EAST TOWN CROSSING

The submitted civil plans contain review comments ("markups") that must be addressed prior to landuse approval as well as informational comments that can be addressed at time of civil application. Please refer to the DRT Letter "Action Items" for markups that must be addressed for landuse approval. [Prelim. Civil Dwg Part 2, Pg 1 of 15]

EAST TOWN CROSSING SEC. 26,35/ TWP. 20 N./ RGE. 4 E., W.M. PIONEER WAY E. FRONTAGE STORM PLAN

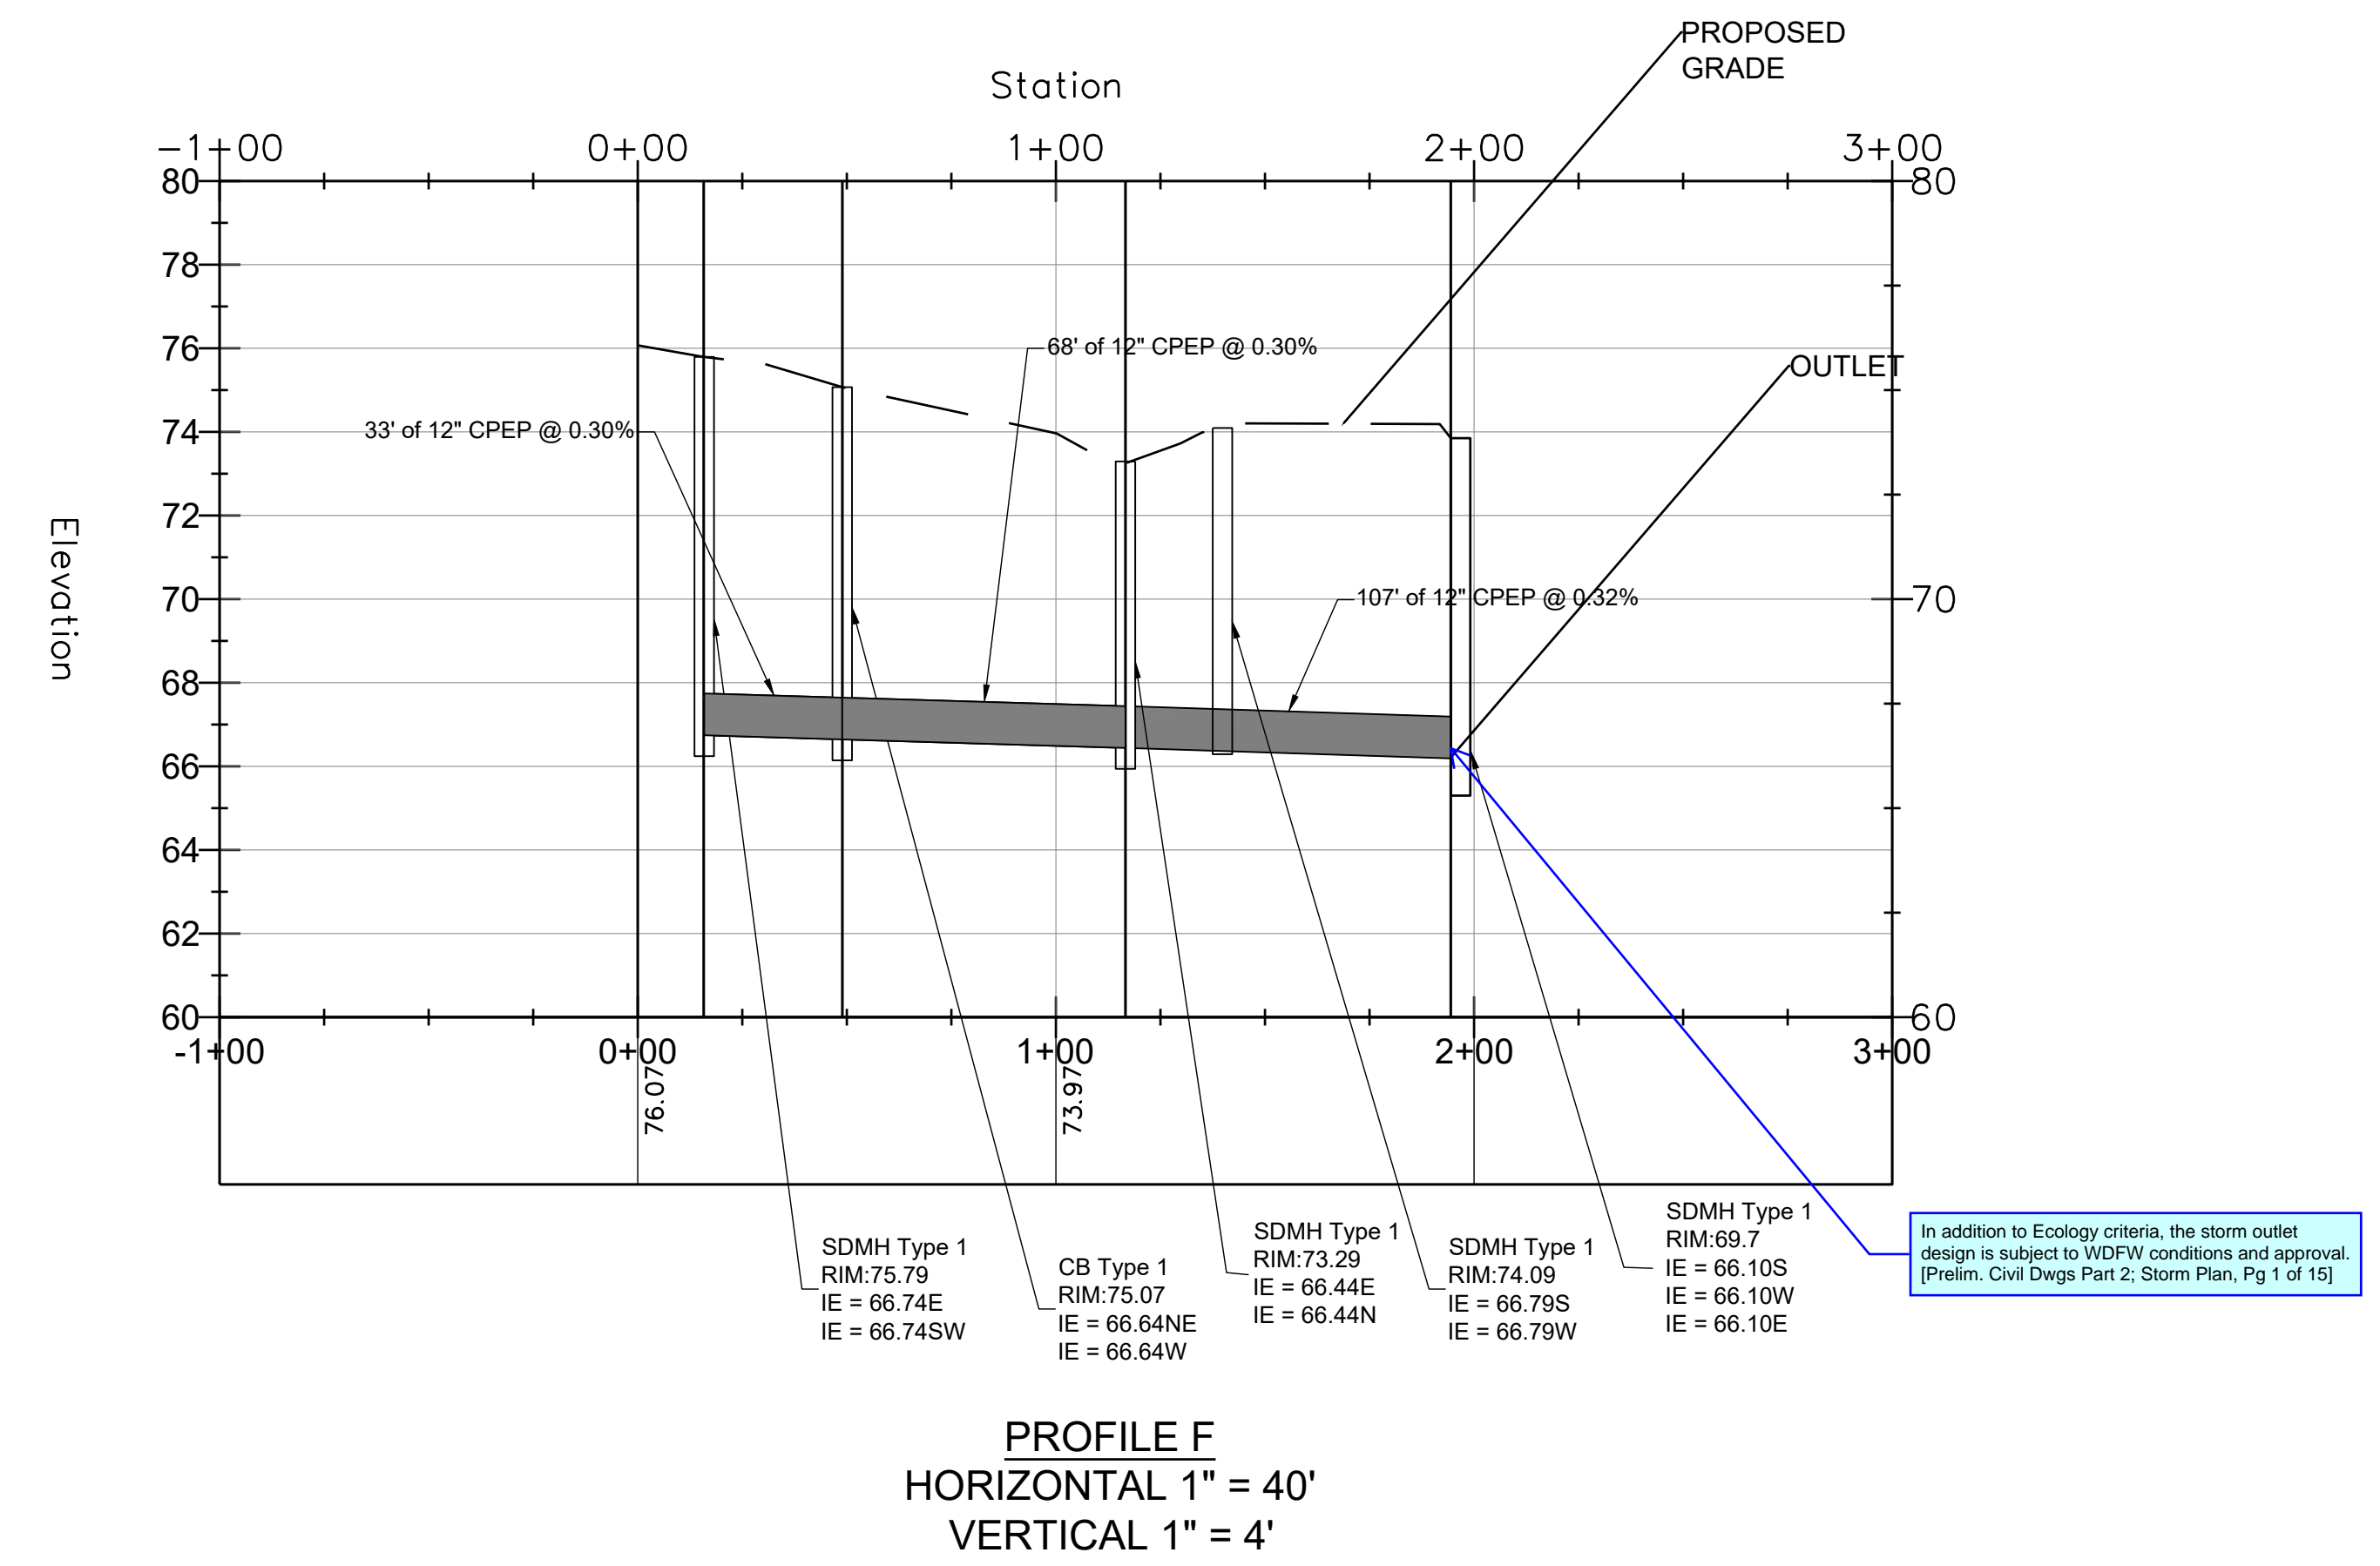
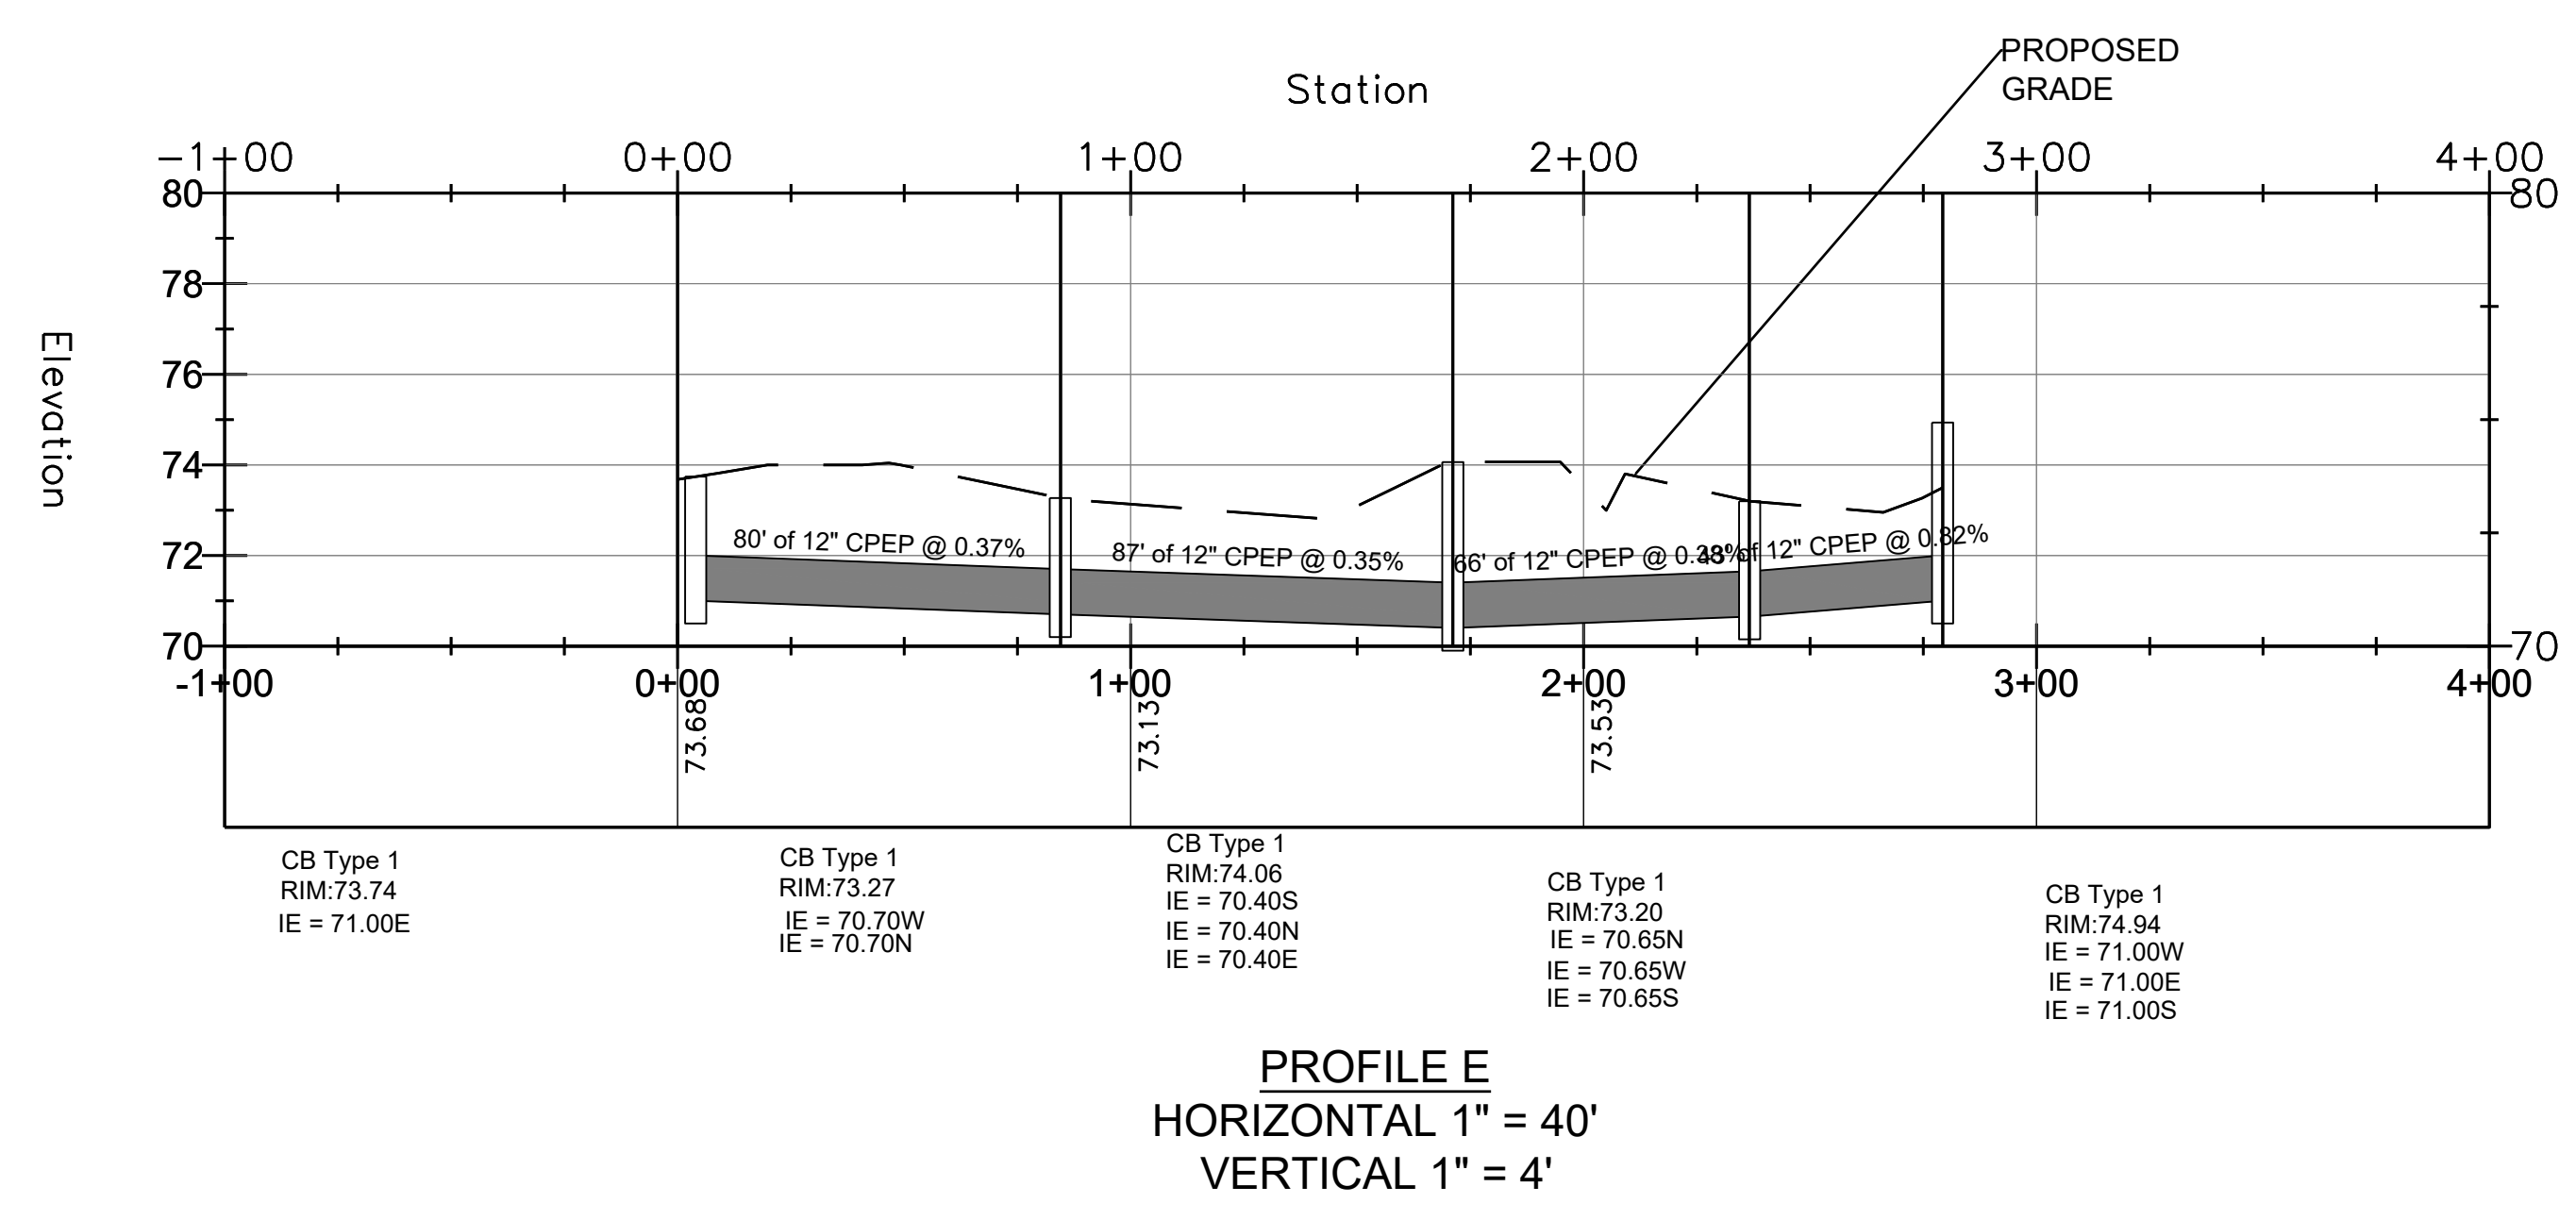
Sheet duplicated on Pg 13 of 15 of Part 1 Civils. [Prelim. Civil Dwg Part 2, Storm Plan, Pg 1 of 15]

To be finalized at civil application. [Prelim. Civil Dwg Part 2, Storm Plan, Pg 1 of 15]

In addition to Ecology criteria, the storm outlet design is subject to WDFW conditions and approval. [Prelim. Civil Dwg Part 2, Storm Plan, Pg 1 of 15]

3 VAULT DETAIL
SCALE: NTS

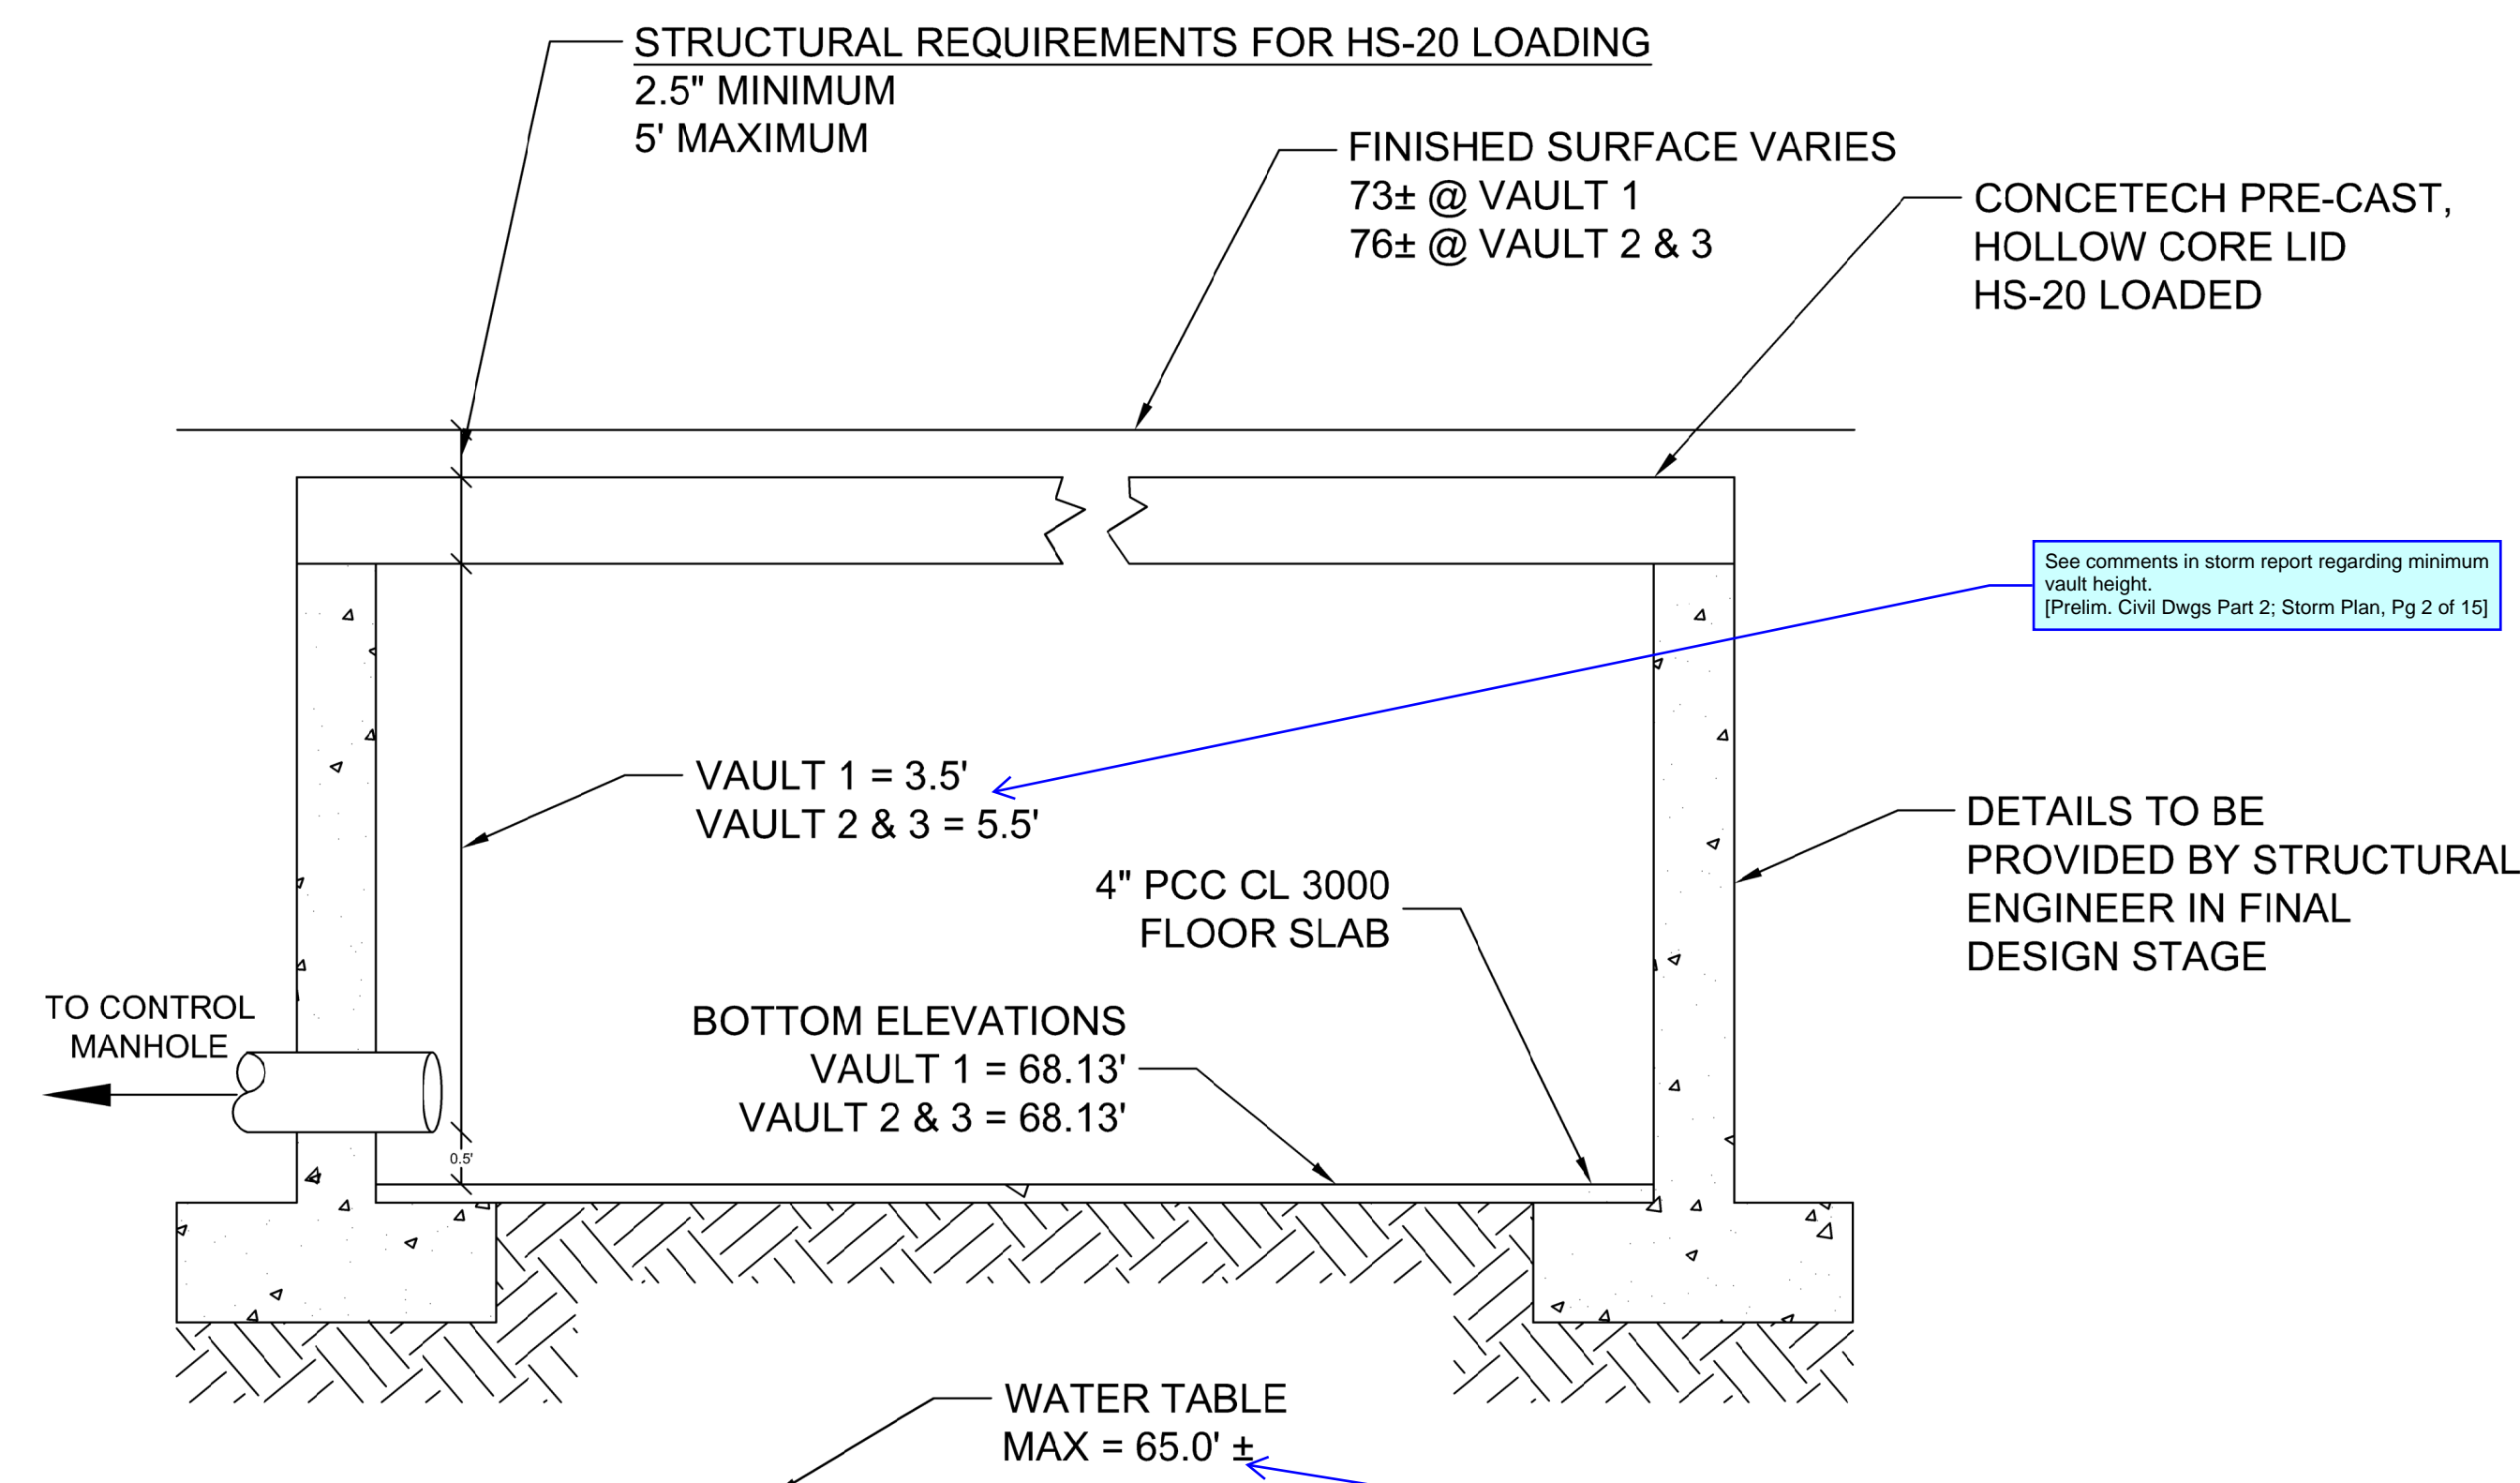
Per Fire Code Official, vault lid must account for fire apparatus outrigger loading anywhere on the vault lid if located within a drive lane. [Prelim. Civil Dwg Part 2; Storm Plan, Pg 2 of 15]

Confirm with groundwater monitoring results (69.6' and 70.6' per Figure A8 in previous storm report). [Prelim. Civil Dwg Part 2; Storm Plan, Pg 2 of 15]
